WEST MOBILE TERRACE SUBDIVISION, BLOCK 21, RESUBDIVISION OF LOTS 31 – 50

WEST MOBILE TERRACE SUBDIVISION, BLOCK 21 RESUBDIVISION OF LOTS 31-50

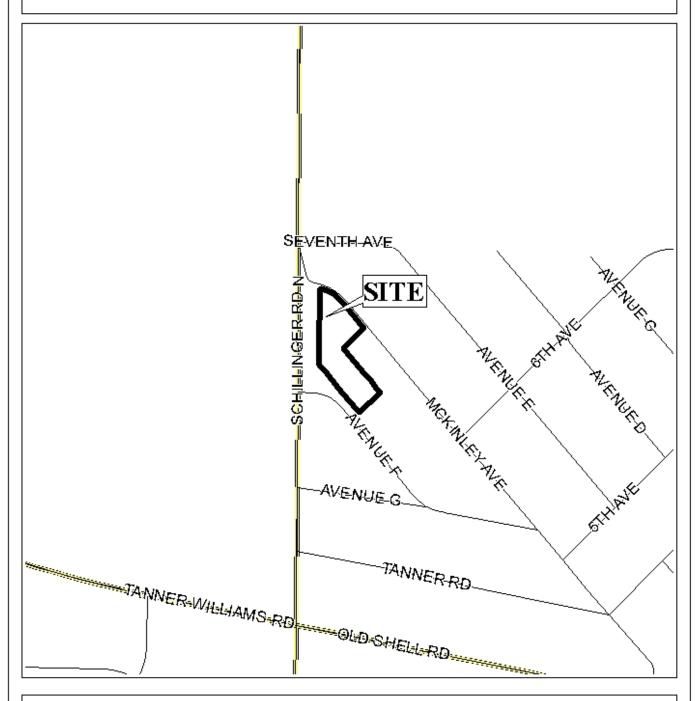
Access management is a concern as the subdivision site fronts onto three streets, which includes a major street and an unpaved minor street. Proposed lot "A" will have frontage on Schillinger Road North and McKinley Avenue, and due to the limited frontage width, should be limited to one curb-cut onto each street. Proposed lot "B" will have a majority of its frontage onto Avenue F, a primarily unpaved street, and a very small frontage onto Schillinger Road North, thus it should be limited to one curb-cut onto Avenue F. The size, design and location of all curb-cuts must be approved by the Mobile County Engineering Department.

A minimum building setback line is depicted on the plat, but appears to range from 20 to 25 feet. The plat should be revised to show a 25-foot minimum building setback line from all road frontages, as required in Section V.D.9. of the Subdivision Regulations.

Section V.D.6. of the Subdivision Regulations states that "property lines at street intersection corners shall be arcs having radii of at least 10 feet or shall be chords of such arcs." The plat should be revised to comply with these requirements.

No stormwater facilities are depicted on the plat, however, compliance with the City of Mobile stormwater and flood control ordinances will be required. A letter from a licensed engineer certifying compliance with the City's stormwater and flood control ordinances should be submitted to the Mobile County Engineering Department prior to the issuance of permits.

This site is located in Mobile County, thus a note should be placed on the Final Plat stating that any lots which are developed commercially and adjoin residentially developed property must provide a buffer, in compliance with Section V.A.7. of the Subdivision Regulations.

Finally, the road name for McKinley should be changed from "Boulevard" to "Avenue."

The plat is recommended for Tentative Approval, subject to the following conditions: 1) placement of a note on the final plat stating that lot A is limited to one curb-cut onto Schillinger Road North and one curb-cut onto McKinley Avenue, that lot B is limited to one curb-cut onto Avenue F, and that the size, design and location of all curb-cuts are to be approved by the Mobile County Engineering Department; 2) depiction of the 25-foot minimum building setback line along all street frontages; 3) compliance with Section V.D.6. of the Subdivision Regulations; 4) provision of a letter from a licensed engineer certifying compliance with the City's stormwater and flood control ordinances to the Mobile County Engineering Department prior to the issuance of permits; 5) labeling of each lot with its size in square feet, or provision of a table on the plat with the same information; 6) placement of a note on the Final Plat stating that any lots which are developed commercially and adjoin residentially developed property must provide a buffer, in compliance with Section V.A.7. of the Subdivision Regulations; and 7) correction of the road name for McKinley to McKinley Avenue.
